Access Compliance Report

Public Rights-of-Way

(Curb Ramps)

Intersection ID: N/A	Main Street: PAISLEY_ABBEY_LN	Cross Street: KELBURN_LN	Location: SE
ADA ID: 80F37B145476	Ramp Type: BlendTrans1	Initial Pass/Fail: Fail	Overall Compliance: No
		Severity Score: 8.75

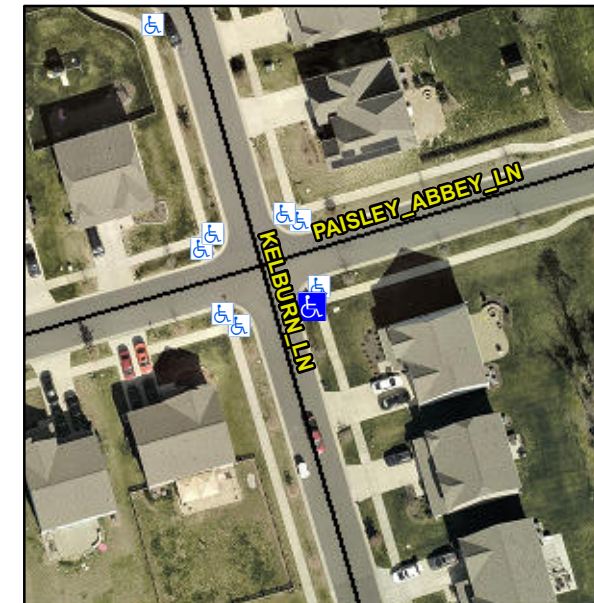
Not Found, R304.5.1

Remove & Replace Curb Ramp With Two New Directional Ramps or Equivalent.
